D2.2 comment resolution

#39,#40,#41,#42,#43

Chris DiMinico
MC Communications
cdiminico@ieee.org

Comment#39

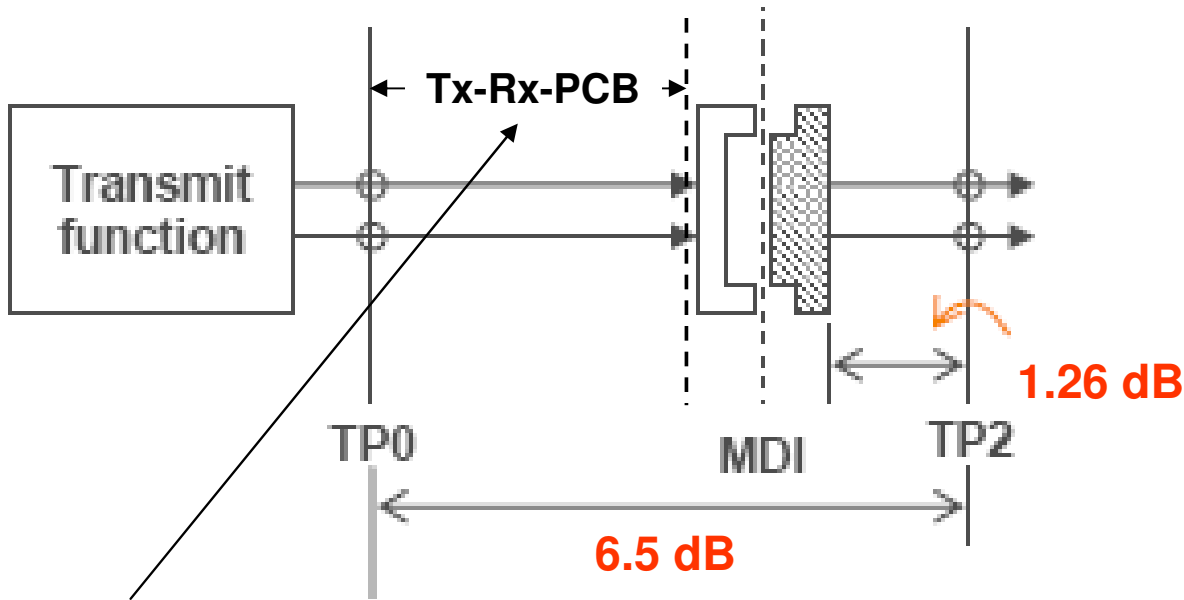
The CR4/10 Host IL (85-14) and the nPPI recommended electrical channel (86A-19) both defined with connector and test fixtures) should be IDENTICAL also for low frequencies (see page 4 of mazzini_01_0909).

Harmonize the curves as above.

PROPOSED ACCEPT IN PRINCIPLE.

Change equation (85-14)

$$\begin{array}{ll} 0.114+0.8914 \times \sqrt{f}+0.846 \times f & 0.05 \leq f < 7 \\ - 35.91 + 6.3291 \times f & 7 \leq f < 8 \\ 14.72 & 8 \leq f \leq 10 \end{array}$$

To:

$$\begin{array}{ll} 0.682 & 0.05 \leq f < 0.2 \\ 0.114+0.8914 \times \sqrt{f}+0.846 \times f & 0.2 \leq f < 7 \\ - 35.91 + 6.3291 \times f & 7 \leq f < 8 \\ 14.72 & 8 \leq f \leq 10 \end{array}$$

Comment#40

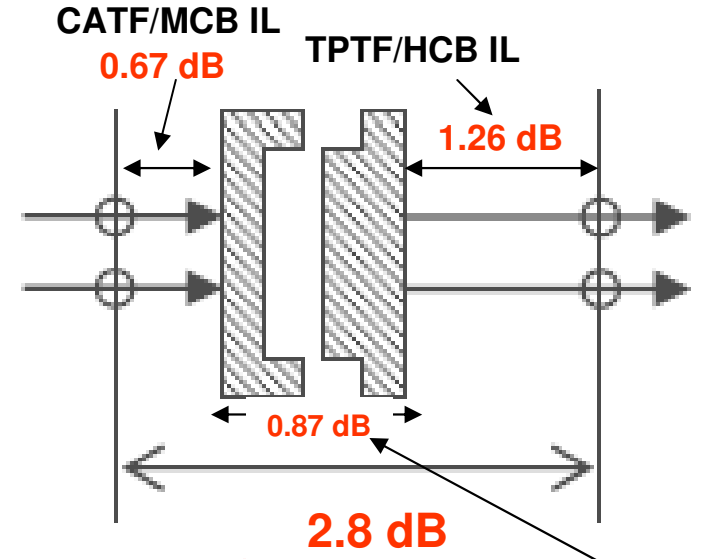
The recommended maximum loss for the PCB only (without connector) (Draft 2.2, page 446, row 51), should be aligned with formula 85A-2 (Transmitter and receiver differential printed circuit board trace loss) that gives maximum PCB loss @5.156GHz = 3.5dB (see page 4 of mazzini_01_0909).

Alternative 1 Host PCB loss = 3.5dB

$$TP0 \text{ to } TP2 = 6.5 = [3.5] + [Mated \text{ connector IL}] + [1.26]$$

$$[Mated \text{ connector IL}] = 6.5 - [3.5] - [1.26]$$

$$\underline{Mated \text{ connector IL} = 1.74 \text{ dB}}$$

Alternative 2 Host with Mated connector IL same as used in test boards $[2.8 - 1.26 - 0.67] = 0.87 \text{ dB}$

$$TP0 \text{ to } TP2 = 6.5 = [TxRxPCB] + [0.87] + [1.26]$$

$$[TxRxPCB] = 6.5 - [0.87] - [1.26]$$

$$TxRxPCB = 4.37 \text{ dB}$$

Comment#43 - resolution to #43,#41,#42

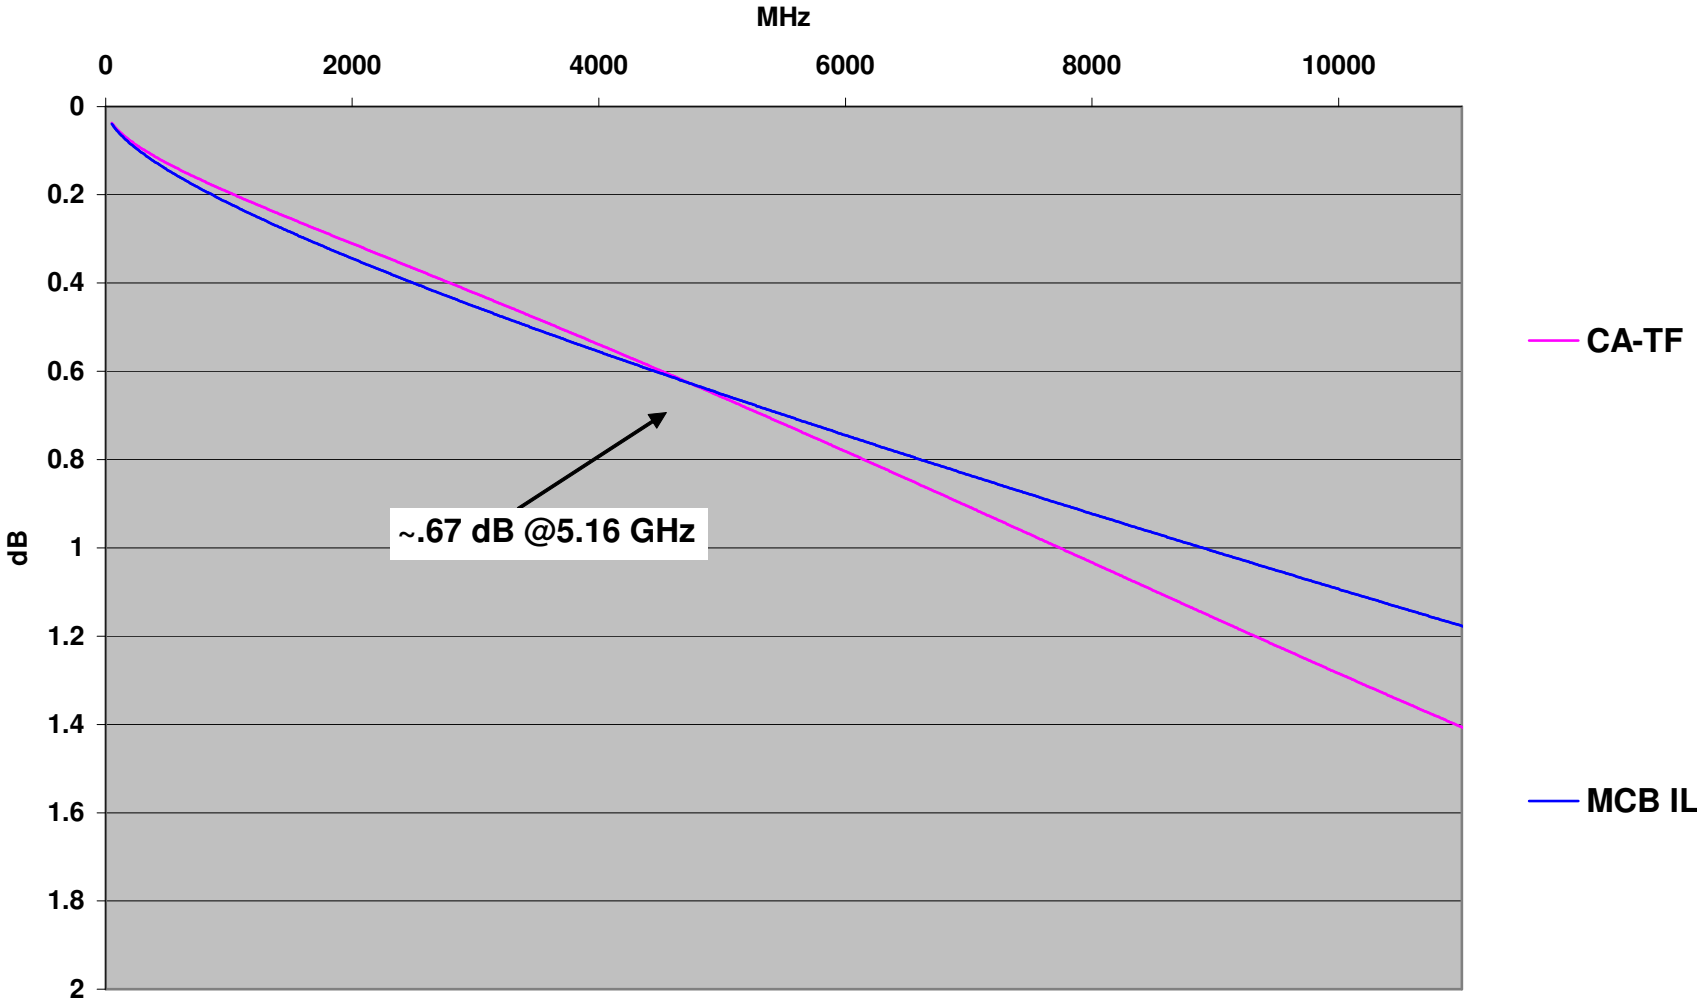
The cable assembly test fixture (85-35) and the MCB (86A-5) loss formulas must be IDENTICAL. In D2.2 losses just cross at same value @ 5.165GHz (see page 5 of mazzini_01_0909).

The test fixture (85-16) and the HCB (86A-4) loss formulas must be IDENTICAL. In D2.2 losses just cross at same value @ 5.165GHz. (see page 5 of mazzini_01_0909).

The connector loss (calculated as 85-37 values minus 85-35 and 85-16) of the test fixture improves when frequency increase (see slide 5). Above formulas should be corrected to avoid this.

(1)Replace 85.8.3.7 Test fixture insertion loss equation (85-16).
With 86A.5.1.1.1 Reference through responses (SDD21) of HCB and MCB For the HCB, equation (86A-4) using frequency range of 0.05 Ghz to 6 GHz (6 GHz >change to 10 GHz).

(2)Replace 85.10.9 Cable assembly test fixture equation (85-35).
With 86A.5.1.1.1 Reference through responses (SDD21) of HCB and MCB For the MCB, equation (86A-5) using frequency range of 0.05 Ghz to 6 GHz (6 GHz >change to 10 GHz).
